Access Compliance Report

Public Rights-of-Way

Intersection ID: 11610	Main Street: COLE_DR	Cross Street: GLENVILLE_AV	Location: SE
ADA ID: 03E3D968271E	Ramp Type: PerpDiag	Initial Pass/Fail: Fail	Overall Compliance: No
Severity Score: 12.5			
Codes/Mitigation Info/Possible Solution		Field Measurements/Component Compliance

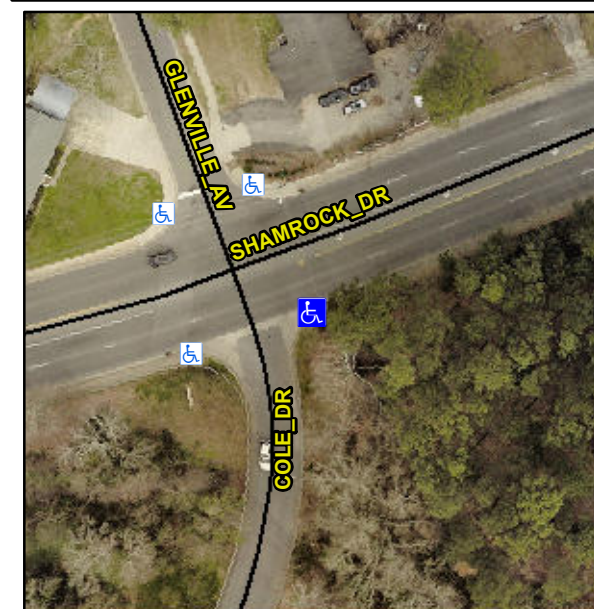
Not Found, R304.2.2

Compliance	Description	Data	Compliance	Description	Data
N/A	Ramp Length (in)	60.0	No	Ramp Slope (%)	8.6
Yes	Ramp Width (in)	48.0	Yes	Ramp XSlope (%)	0.2
N/A	Flare Type LT	N/A	N/A	Flare Type RT	N/A
N/A	Flare Slope LT (%)	N/A	N/A	Flare Slope RT (%)	N/A
N/A	Flare Traversable LT?	N/A	N/A	Flare Traversable RT?	N/A
N/A	Landing Length (in)	N/A	N/A	DWS Provided?	N/A
N/A	Landing Width (in)	N/A	N/A	DWS Contrast?	N/A
N/A	Landing Slope (%)	N/A	N/A	DWS Length (in)	N/A
N/A	Landing X Slope (%)	N/A	N/A	DWS Full Width?	N/A
N/A	Landing Curb? (Y/N)	N/A	N/A	DWS Offset (in)	N/A
N/A	Shared Landing?	N/A			
N/A	Gutter Ponding?	N/A	N/A	Gutter Slope (%)	N/A
N/A	Gutter Lip Ht (in)	N/A	N/A	Gutter X Slope (%)	N/A
N/A	Painted X Walk1?	No	N/A	Painted X Walk2?	No
	X Walk 1 Direction	To N		X Walk 2 Direction	To W
N/A	X Walk 1 Width (in)	N/A	N/A	X Walk 2 Width (in)	N/A
	X Walk 1 Slope (%)	2.2		X Walk 2 Slope (%)	1.6
	X Walk 1 X Slope (%)	2.3		X Walk 2 X Slope (%)	2.1

Remove & Replace Curb Ramp With Two New Directional Ramps or Equivalent.
